DATE: 04.18.2016
TO: ProTrak
FROM: Bill McDow
Transportation Planning

■ **ELEMENT BARCLAY WEST APARTMENTS [TRC Plan Review]**

∞ Initial Review Note ∞

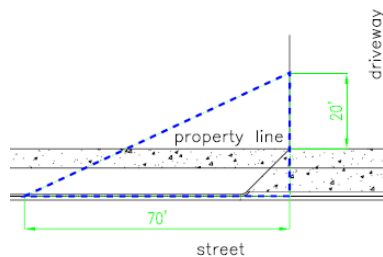
- ❖ A Traffic Impact Analysis (TIA) is under review for this development.
- ❖ The previously submitted designs for Gallery Park Apartments was designed for 402 apartments. This submittal does not have a site data table with the number of apartments, required and proposed parking, or the breakdown of 1 BR, 2 BR or 3 Br apartments proposed.
- ❖ If the number of apartments, proposed for this submission does not match the mix/ total submitted for the TIA, a revision to the TIA may be required.
- ❖ If the TIA has changed, please contact Amy Kimes, PE, Amy.Kimes@wilmingtonnc.gov, at (910) 473-5130, to discuss the TIA review process and begin the scoping discussion.
